SERVICE BULLETIN

MODEL NAME : Di620
MODEL CODE : 1155
NO. : 011
DATE : 981007
SUBJECT : SOFTWARE PROGRAM OF IC70B ON PWB-B CHANGE

IC70B Version : 10G019-00 ➡ 10G032-00

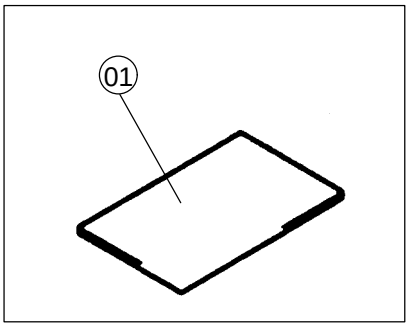
The software program of IC70B on P.W. Board-B has been changed and the following problems have been solved. Due to this, the memory program of the memory card IC (01) has been changed.
